Planning & Zoning Board Staff Report for October 1, 2019 Meeting

SPR #19-12. Request of Majid Kalaghchi for: Approval to construct a new, two-story, 4,393 square foot, single-family home located at 470 Fairfax Avenue on the Howell Creek Canal, zoned R-1AA.

SPR #19-13. Request of Charles Clayton Construction for: Approval to construct a new, two-story, 16,036 square foot, single-family home located at 115 Palmer Avenue on Lake Maitland, zoned R-1AAA.

Scale: 1" = 10'-0"
Date: 2019-09-05
Sheet No.: L1.11
Project No.: 1909000001

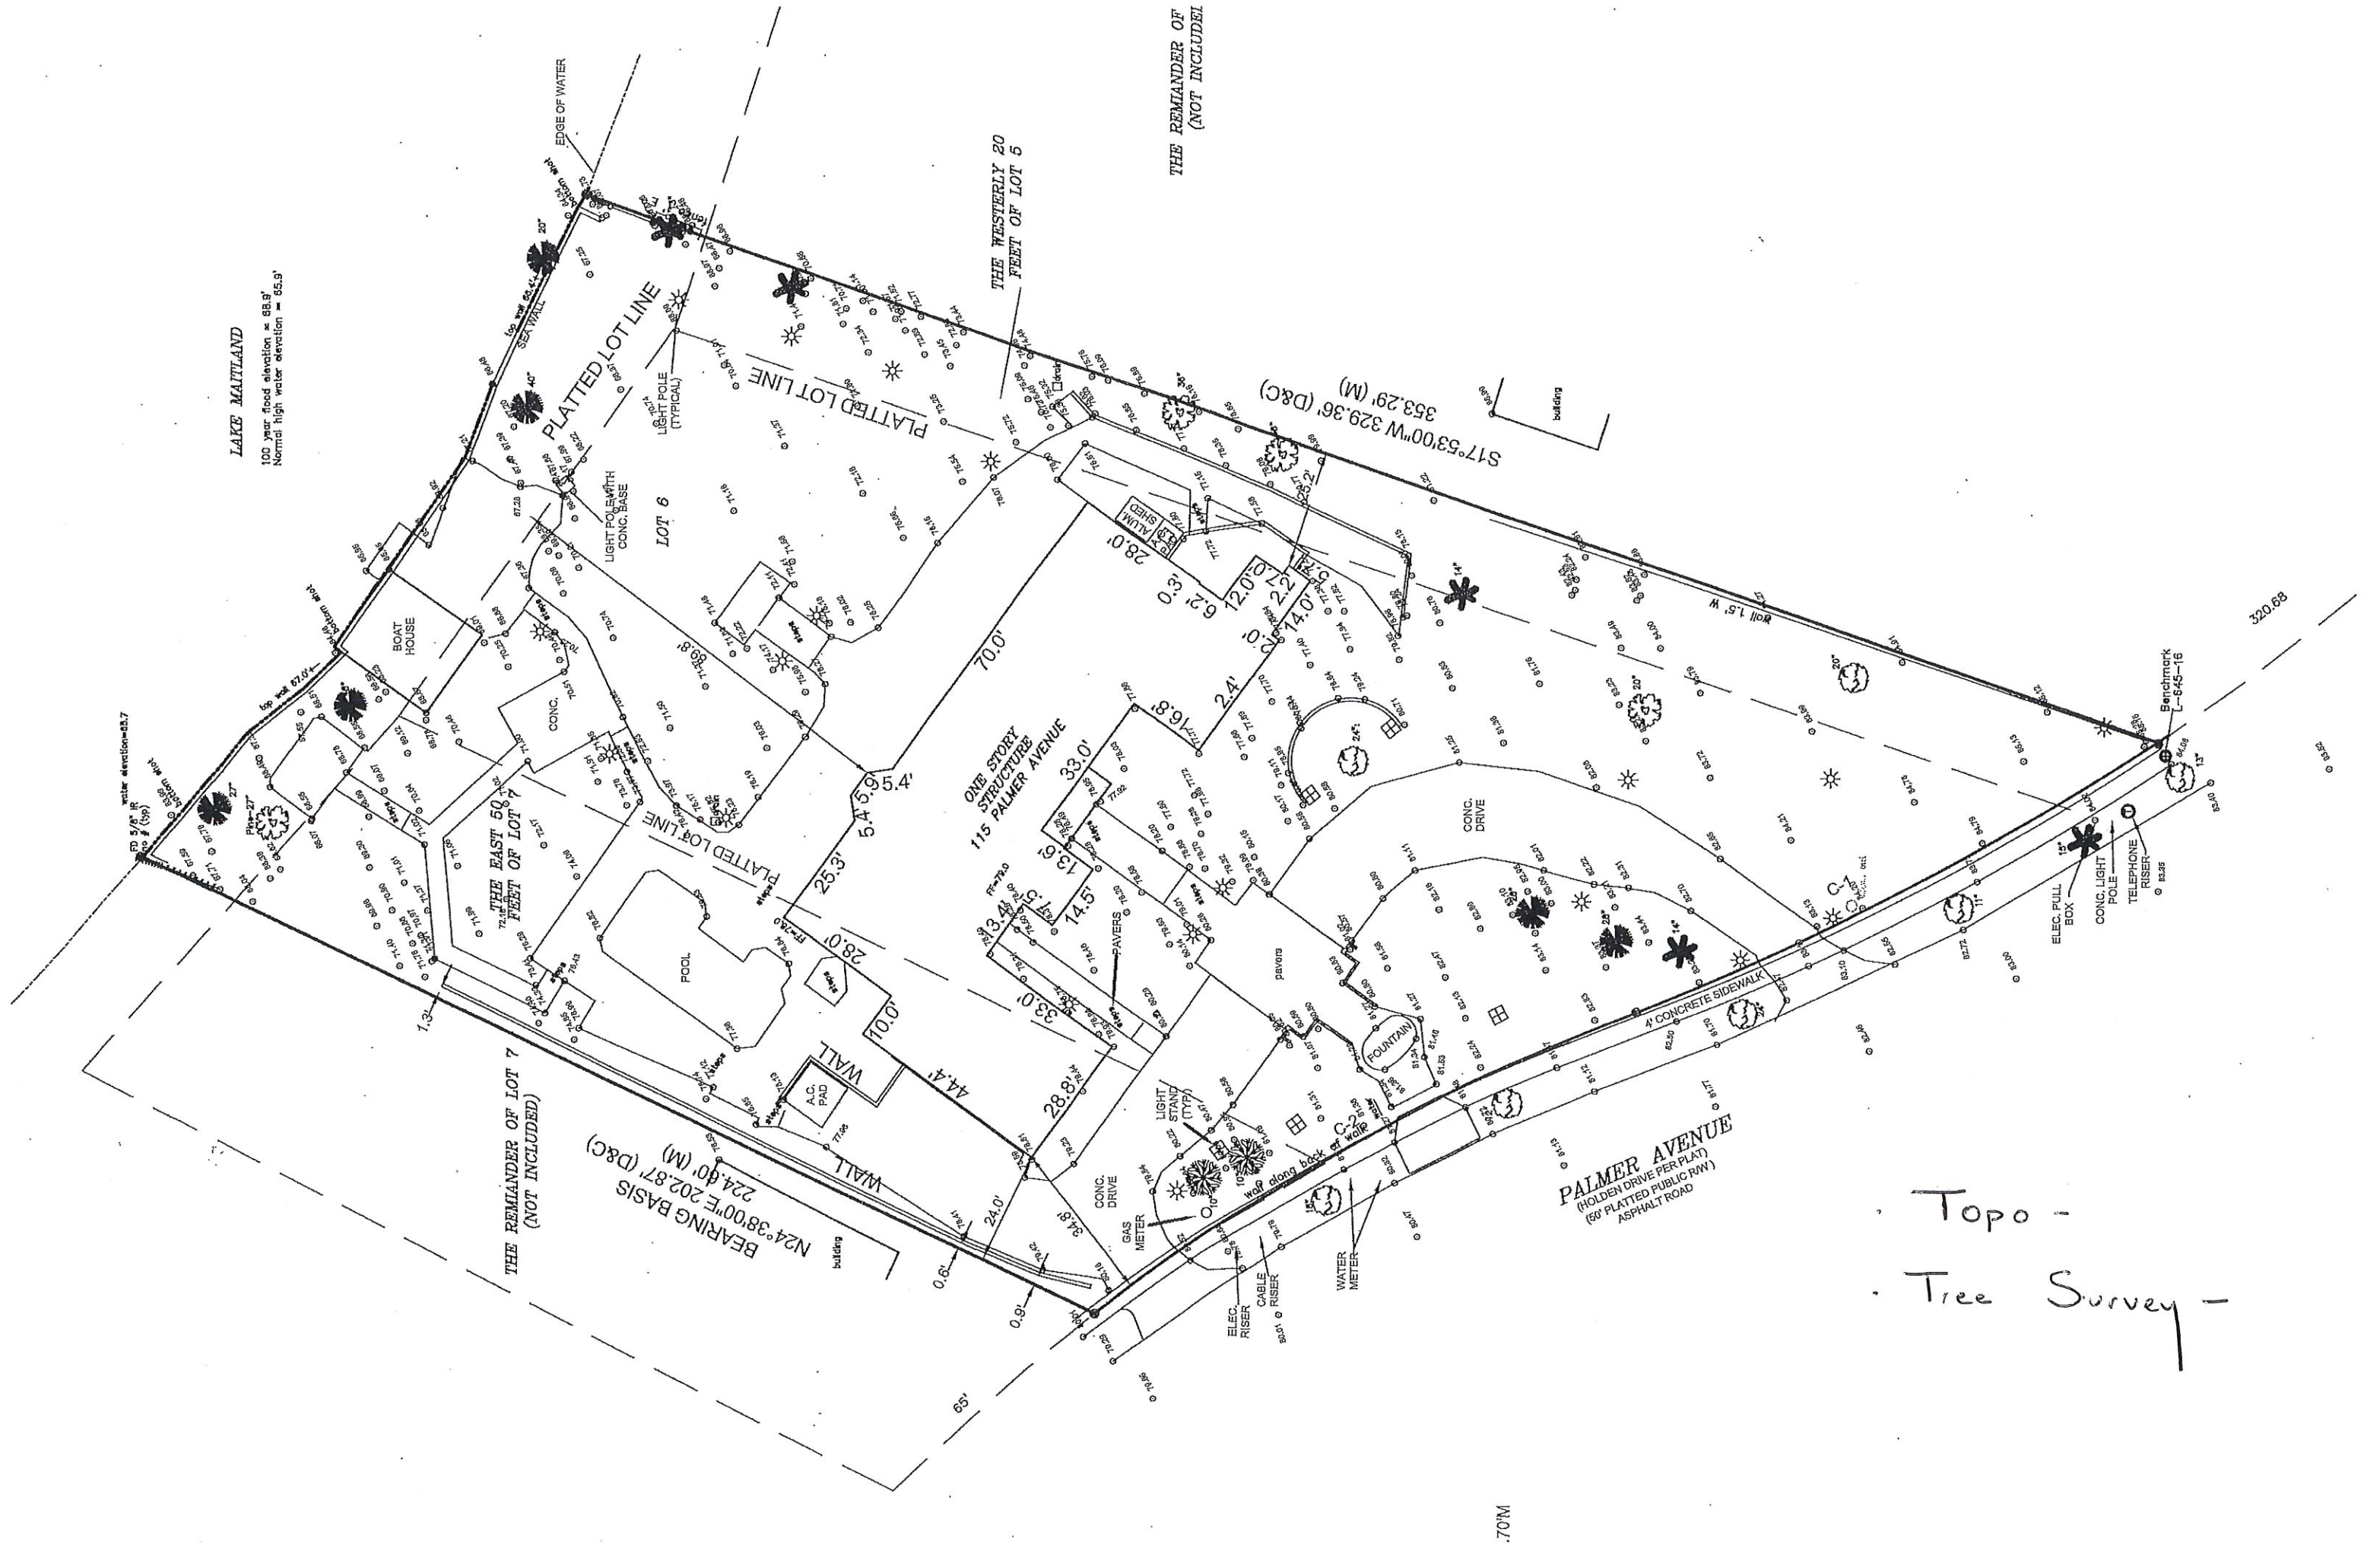
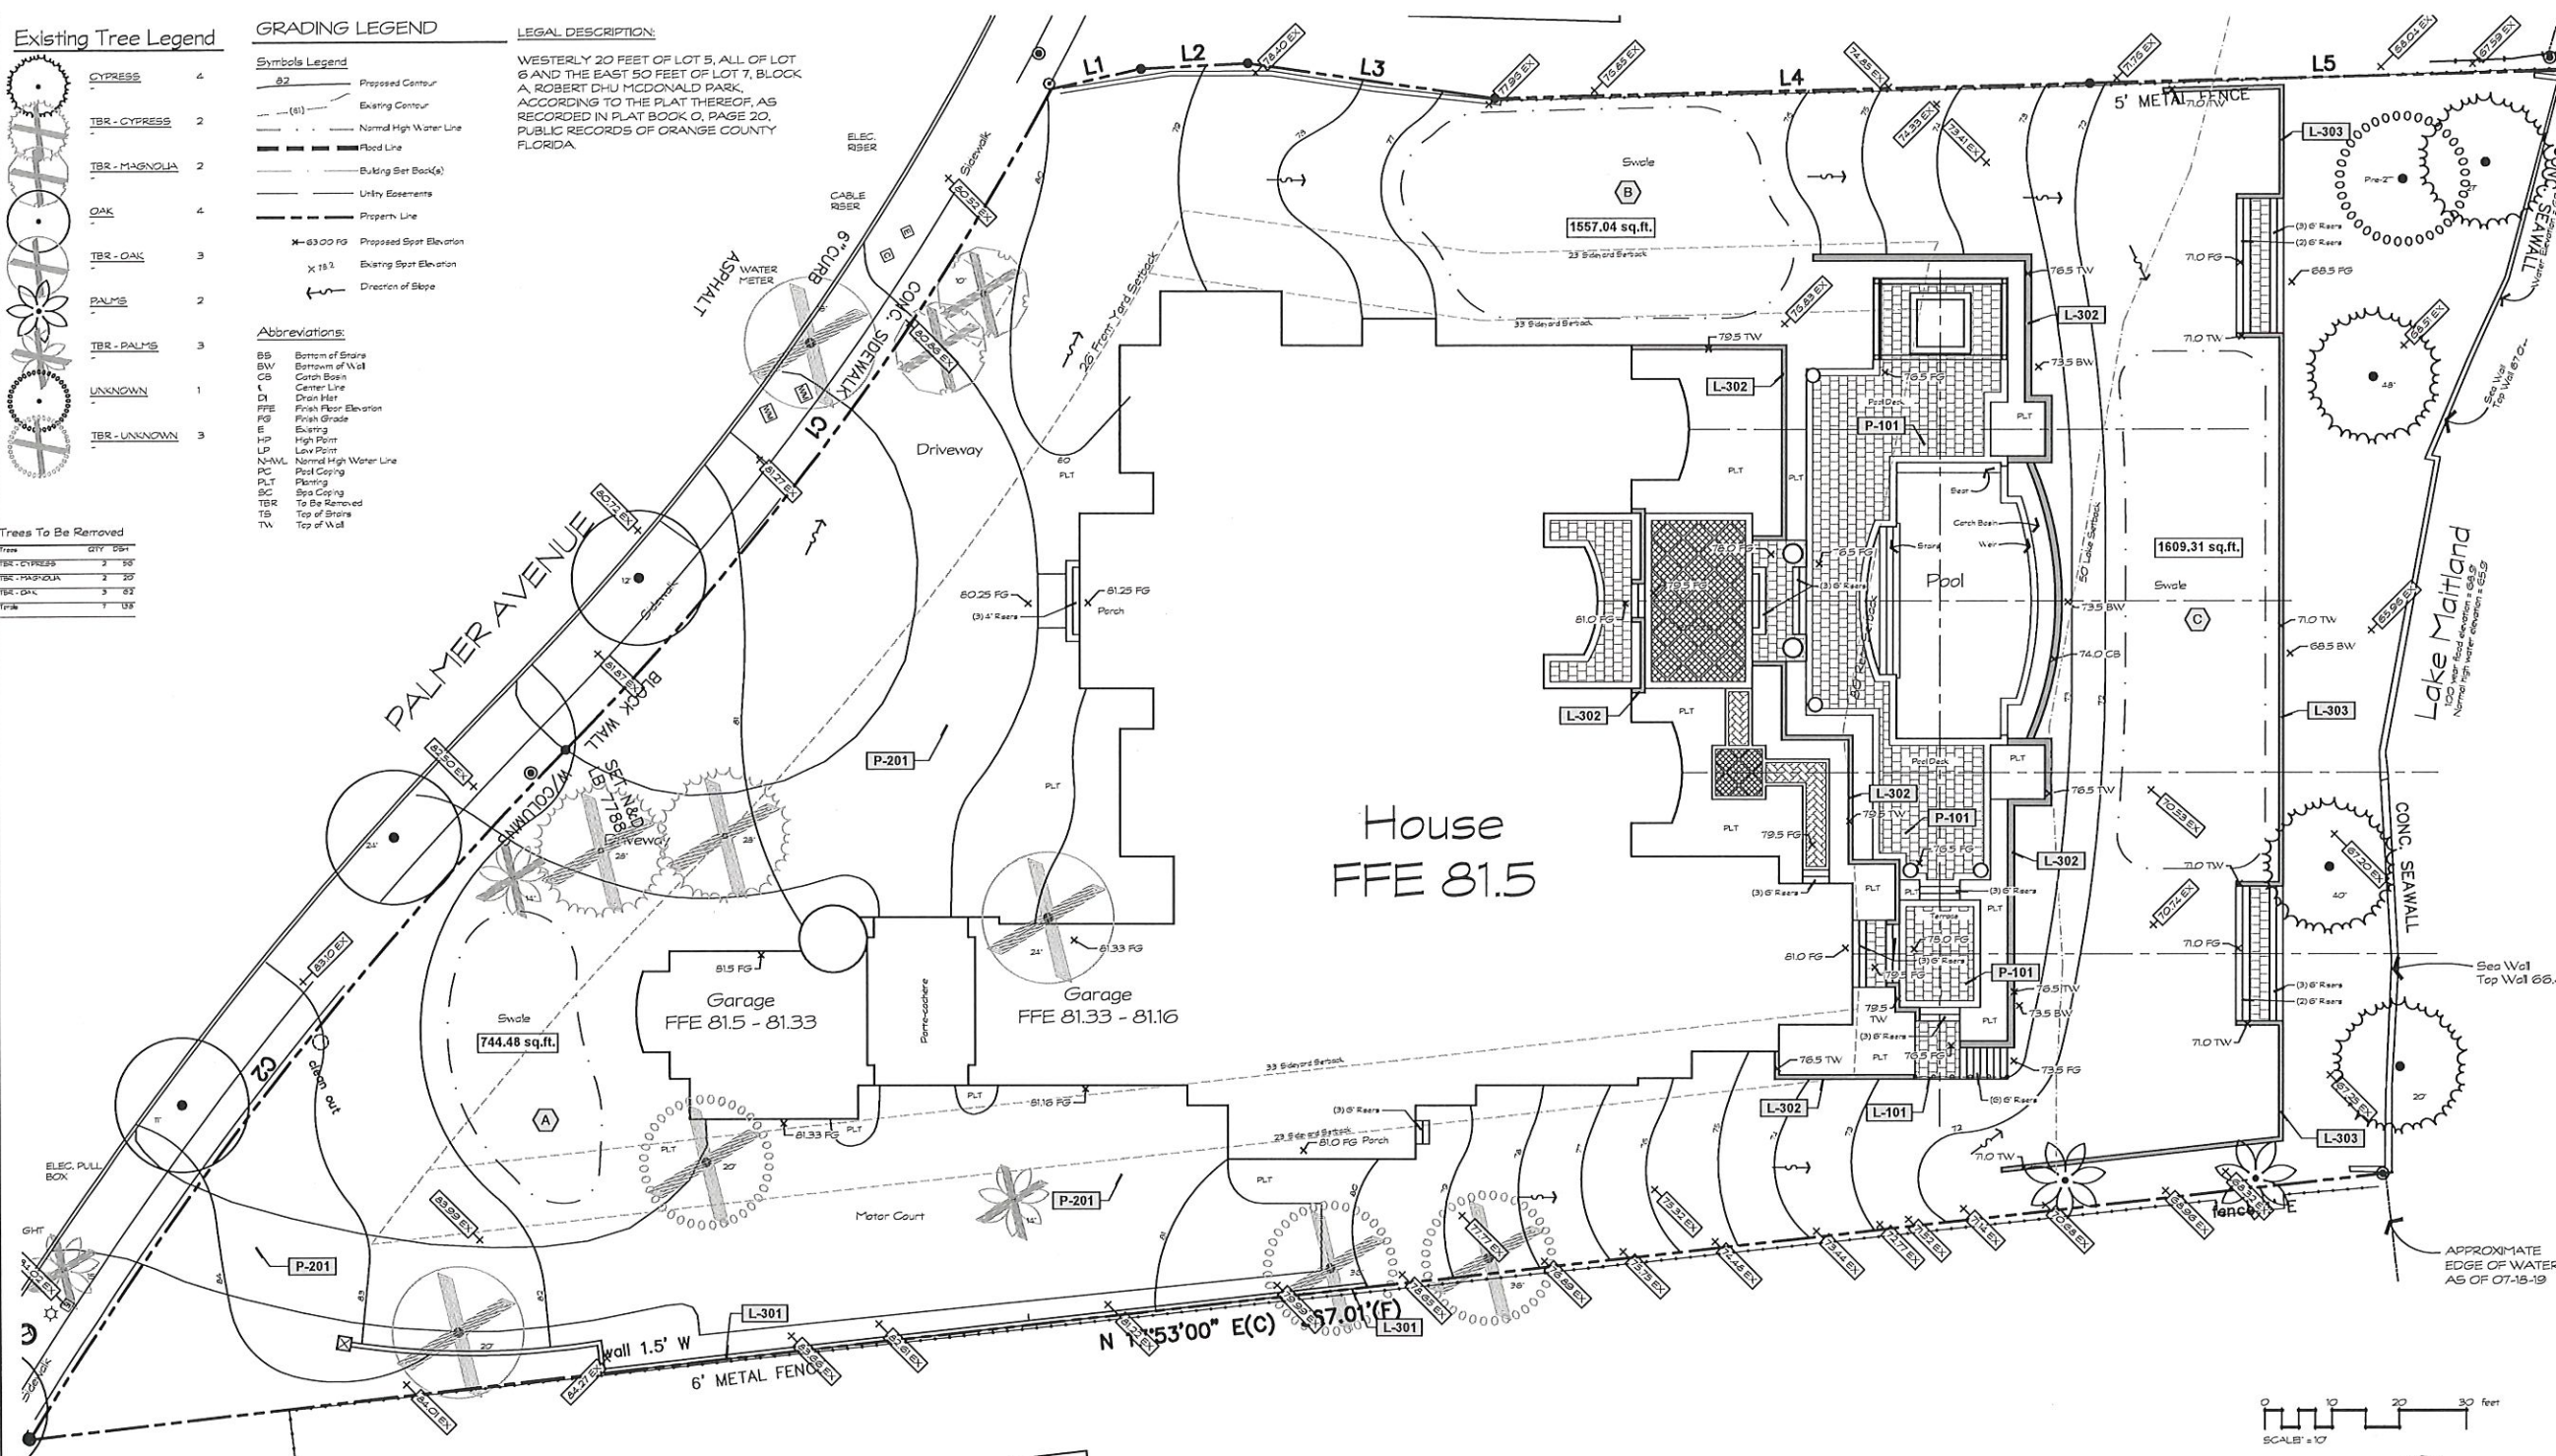
The purpose and intent of the lakefront lots section of the code states that existing trees shall be preserved to the degree reasonably possible, and the appearance of the property and the shore when viewed from the water will be kept as natural as reasonably possible. The applicant is proposing to remove several trees within the front of the lot, and is saving the trees along the lakefront. Based on onsite observation by the city's Urban Forestry Division, most of the trees identified for removal on the site plan are in poor condition and/or are non-protected species (camphor, palms). The Urban Forestry Division further stated that the remaining protected species (oaks) to be removed have a history of excessive and improper pruning, and therefore removing these trees would be permitted with the required mitigation. Per code, conditions for approval of a tree removal permit shall include tree replacement, financial compensation or a combination of tree replacement and financial compensation.

The code limits walls and swimming pool decks facing the lake in excess of three feet in height. While this lot does have a significant grade drop of over ten feet from the front of the house to the lakeside, the applicant is proposing steps leading down from the house to the pool deck and is therefore not exceeding the wall/pool deck height limits of three feet.

The code requires retention of stormwater so that stormwater flowing over a waterfront lawn area does not carry with it into the canal or chain of lakes any fertilizers, herbicides, or other chemicals that affect the water quality of our community's most precious assets. The amount of impervious surface on the lot determines the depth/size of the retention needed. The applicant is proposing a stormwater swale near the lakefront that is sized to meet the City's code requirements.
